Subject: Final Status Report for Decommissioning
Control Number: 137512

Re: West Virginia University Institute of Technology
NRC License No. SNM-1990, Docket 07003071

Additional Information

RADIATION SAFETY SURVEY

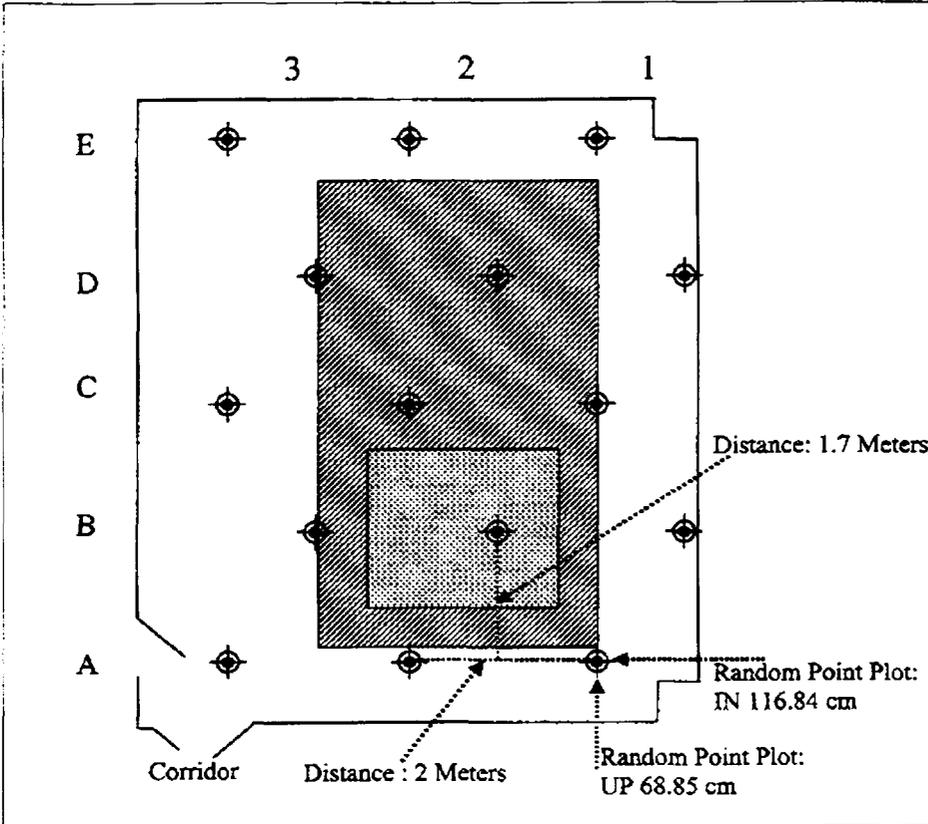
sensitive. In Table 10, it states that the background of the Ludlum 12 with 43-1 detector was 2 cpm; however, in the attachment, "Radiation Safety Survey" of Room 105, it states that the background for the Ludlum 12 with the 43-1 detector was 3.0 cpm; and the background for the Ludlum 5 was 15 microR per hour.

- b. Specify the calculations and the instrument efficiency that was used to determine the results of the static measurements in the "Radiation Safety Survey"; using the efficiency of 0.12 stated in Table 10, we cannot replicate the results.

A corrected report is attached. All results remain less than the DCGL. Attachment 2
